From: Matta, Samir <SFMatta@lan-inc.com>
Sent: Thursday, April 03, 2014 3:57 PM
To: Prysby, Mike (DEQ)
Cc: Busch, Stephen (DEQ)
Subject: Re: Flint WTP - Bray Road Lagoon Proposal - MDEQ comments

Attached are our comments pertaining to submittals received for Phase II – Segments I and II for the Flint WTP. If you have any questions concerning our comments, I will be available till close of business today to discuss with you. After today, you will need to contact Steve Busch concerning any questions regarding the Flint WTP project. I will return from vacation on Monday April 21st.

GENERAL PLAN
Figure 1-Existing Site Layout

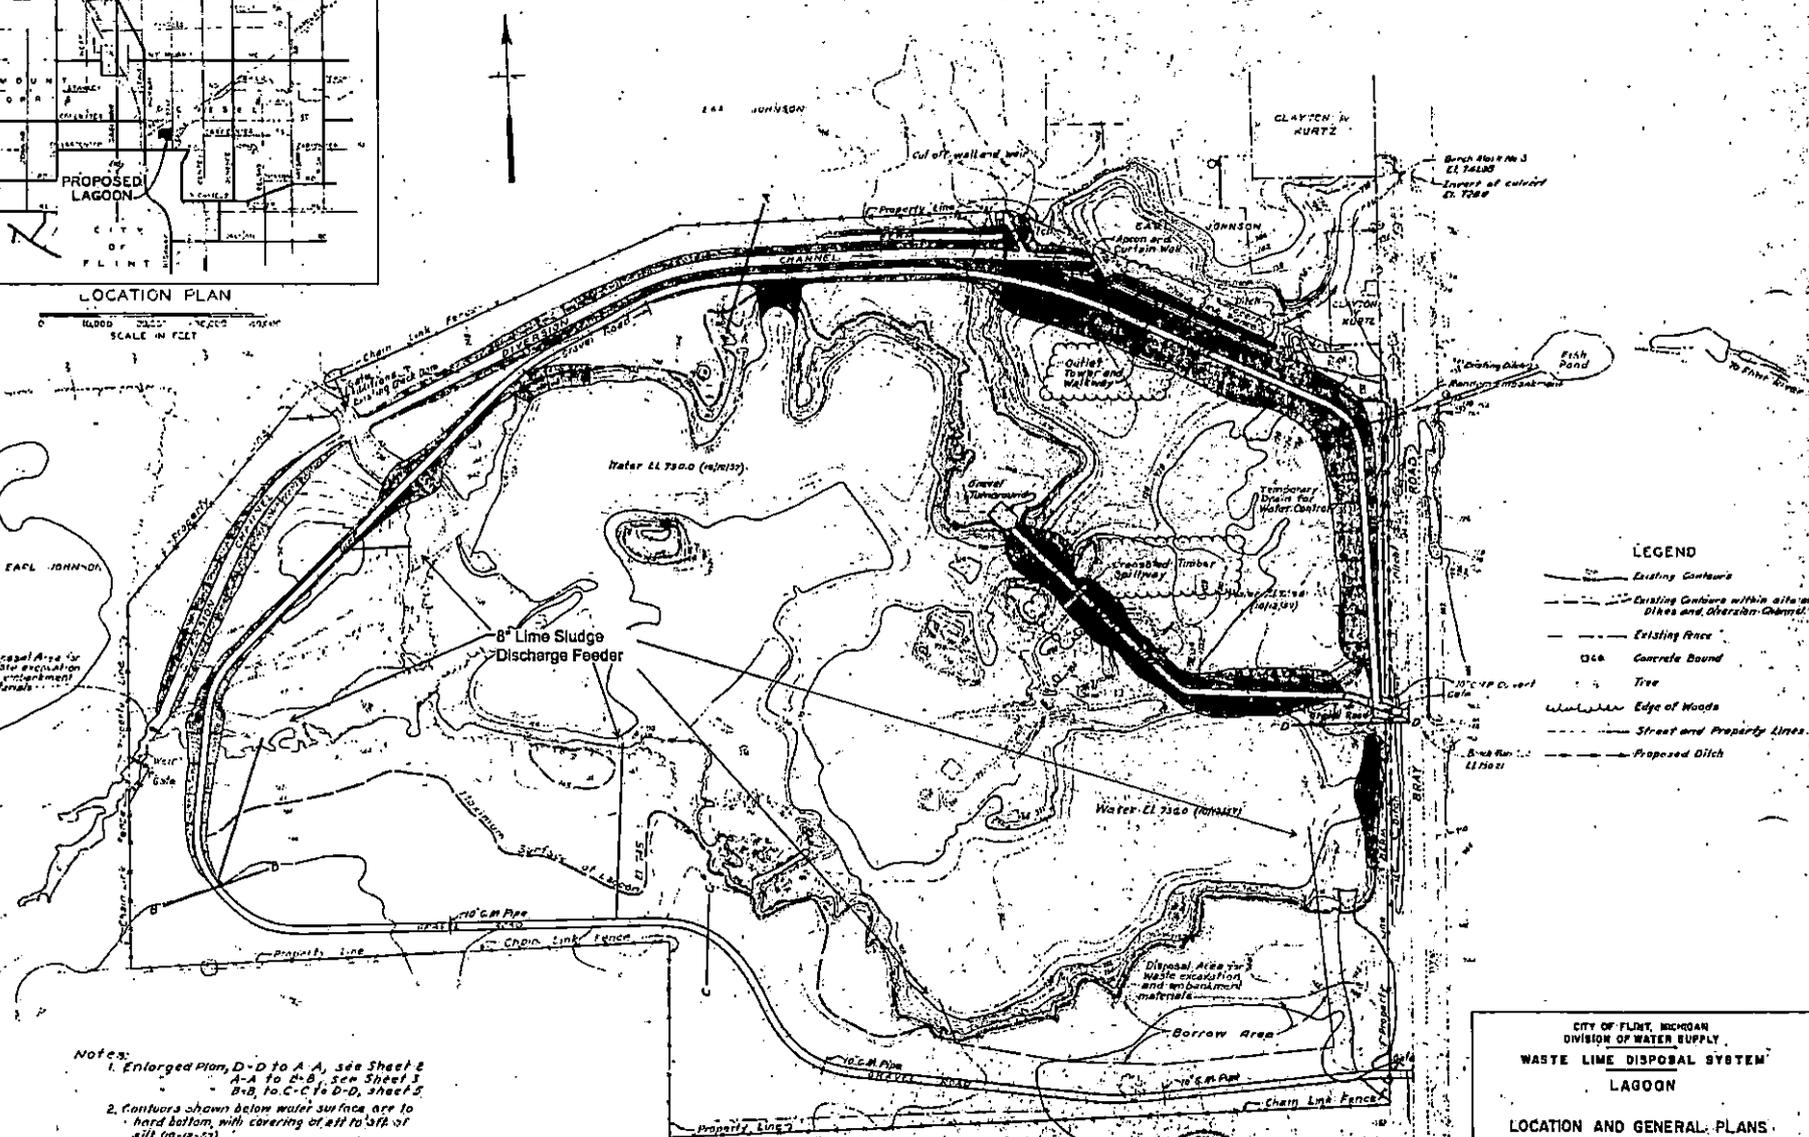
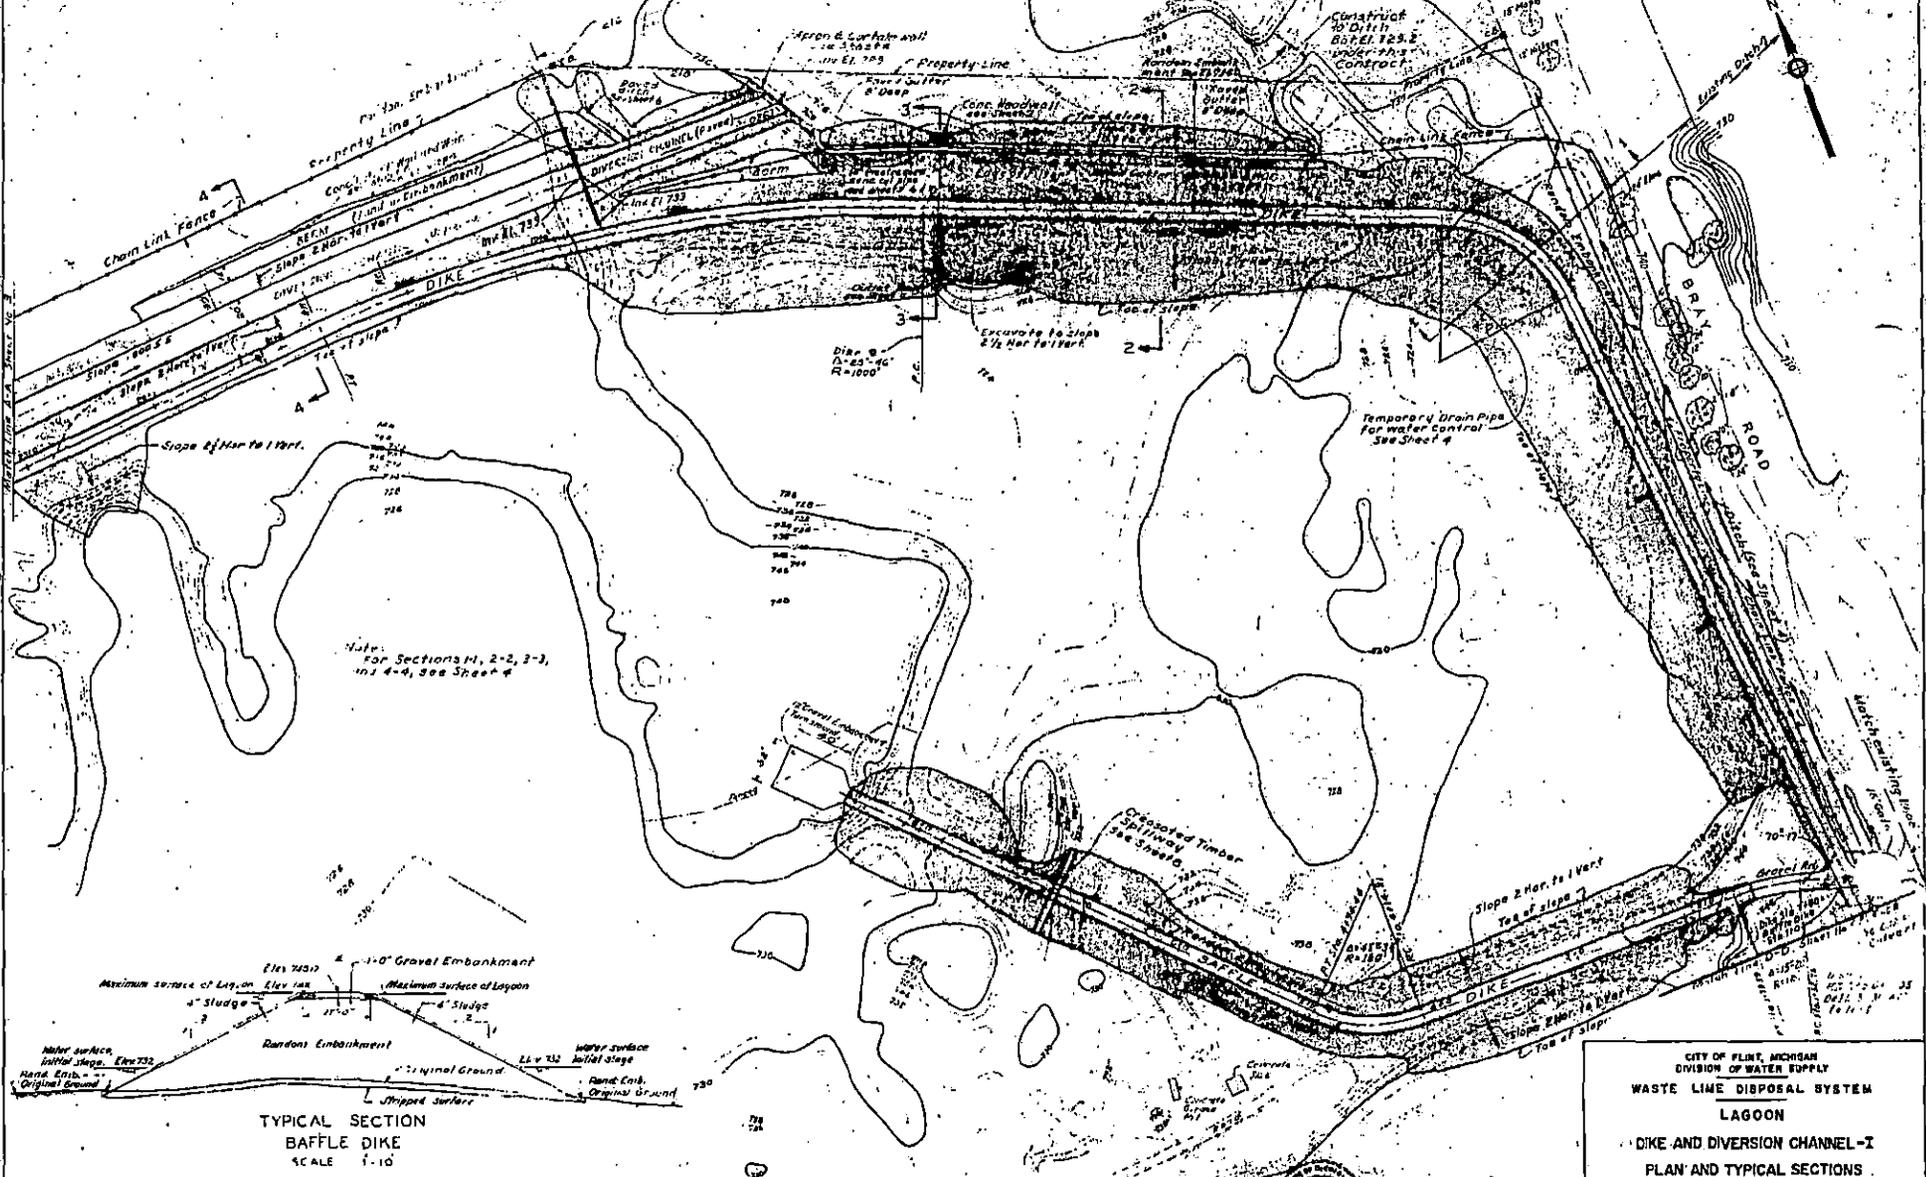
1. Evaluate the existing conditions in comparison to the original site design and its intended functionality in order to evaluate required design changes. Figures 1 & 2 highlight the original design and select key elements while Figure 3 shows the changes that may affect proper operation of the system.
2. Site survey of the project site has been completed. Collected data confirms the plan that the site has the required capacity to handle the continuous full time operation of the plant during the next 30 to 36 months until the KWA system is constructed and connection is made at which time, lime softening will not be required. Figure 4 highlights the current

Figure 3

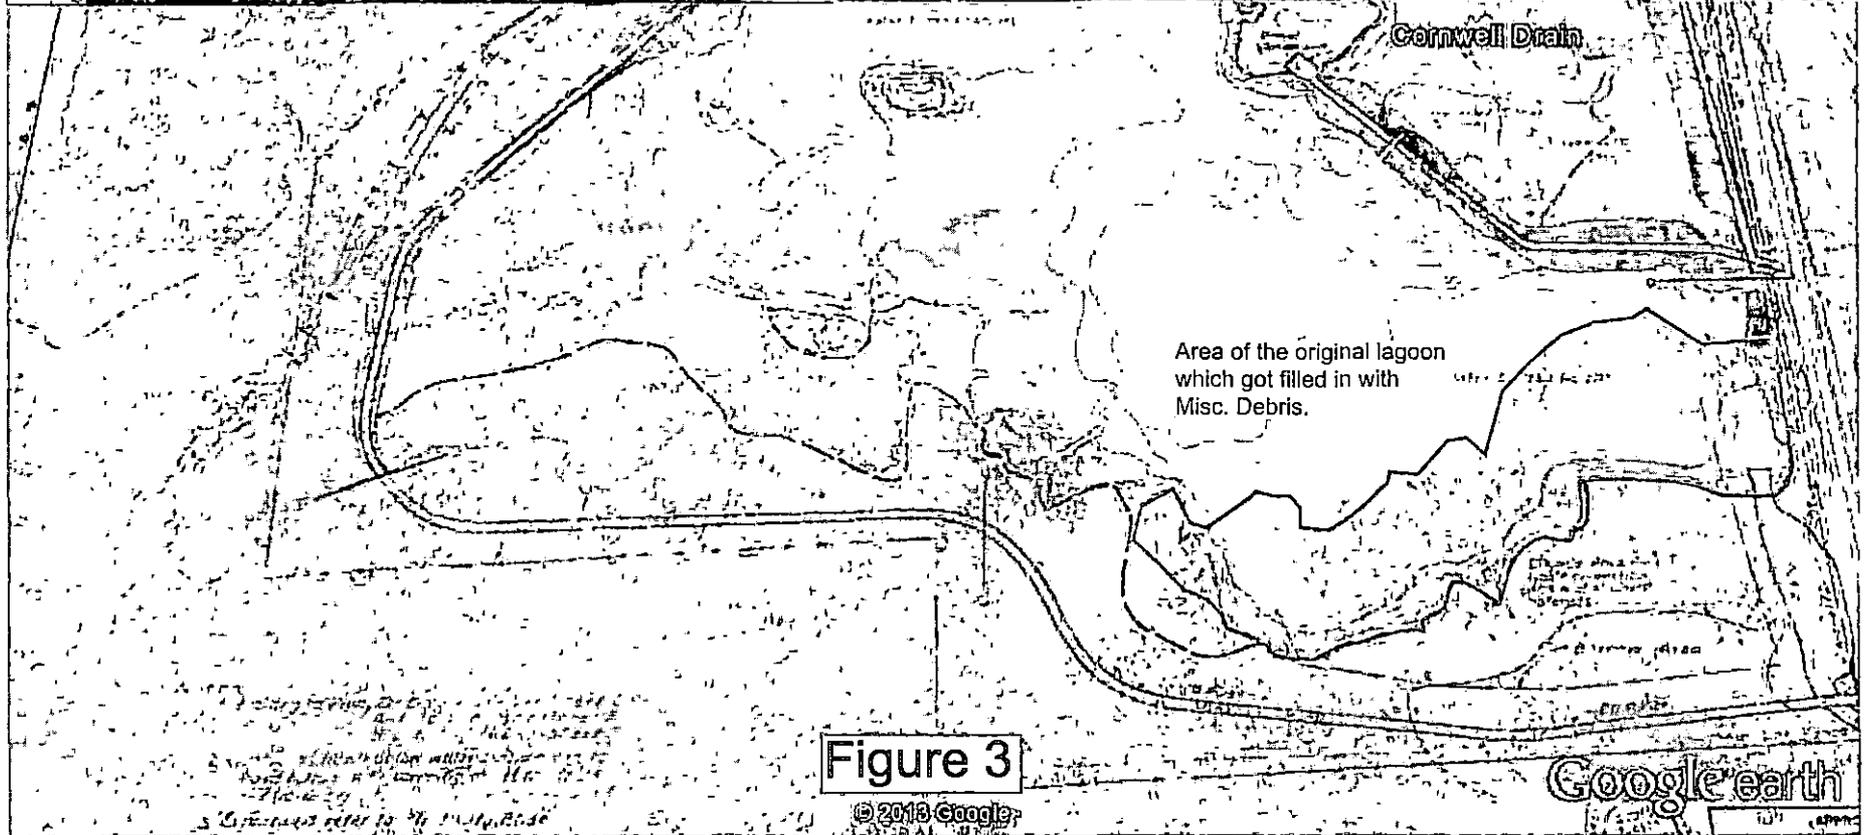
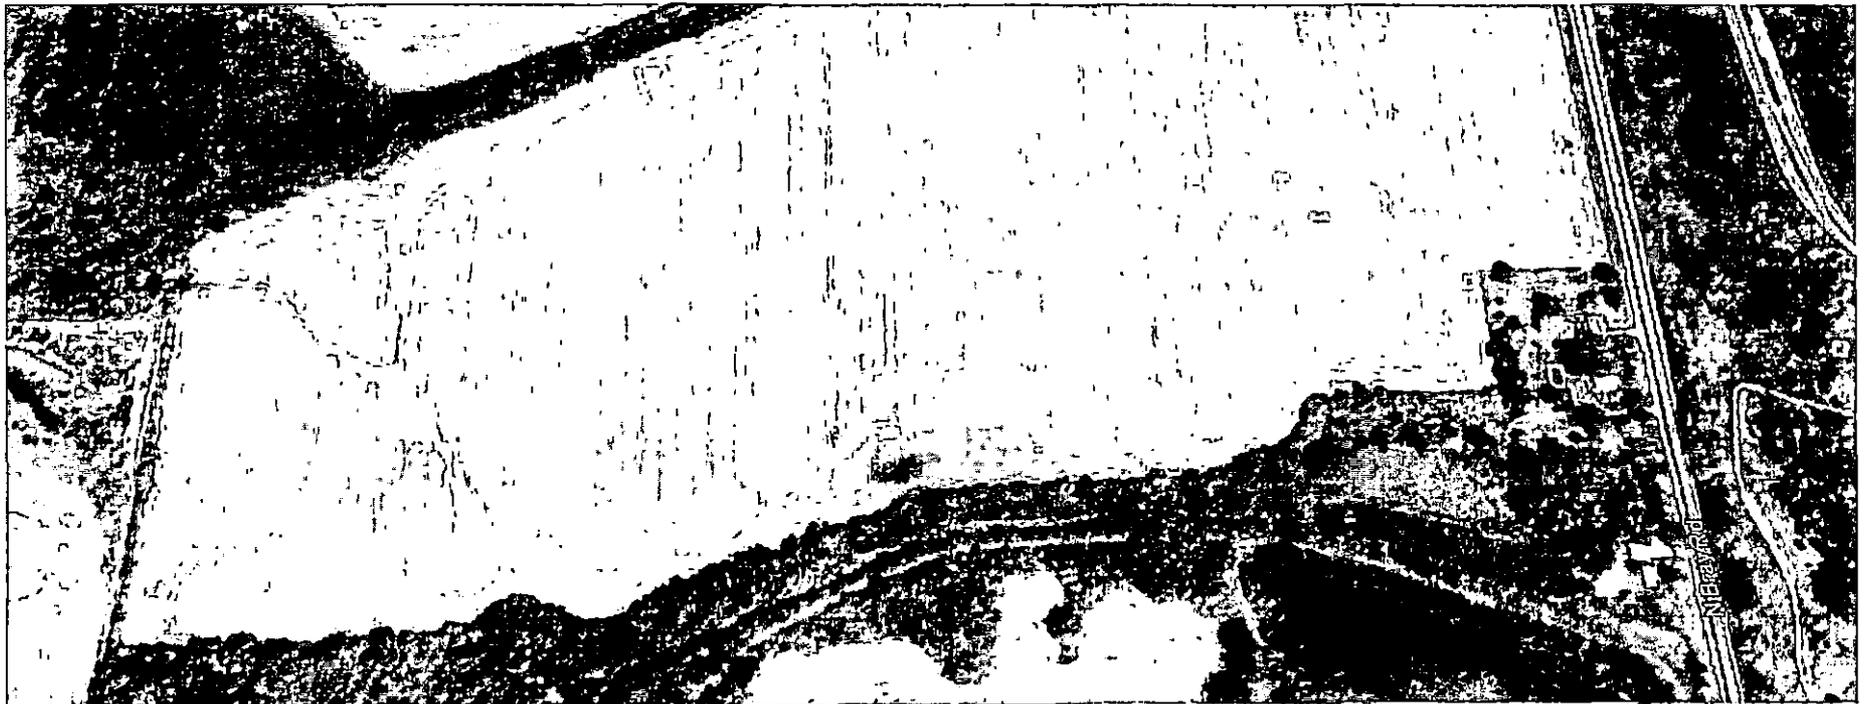
4. A separation barrier will be constructed to isolate the disposal area from the lime sludge discharge bay as shown in Figure 4.
5. A decant structure and submersible pump station will be constructed in the SE corner of the upper lagoon bay to treat and dispose of flows into the City's sanitary system. This system will be fully operational while the plant is treating river water and lime softening is required. A new storm treatment outlet structure may be reestablished with the approval of MDEQ after the KWA connection is online and lime softening is no longer in use.
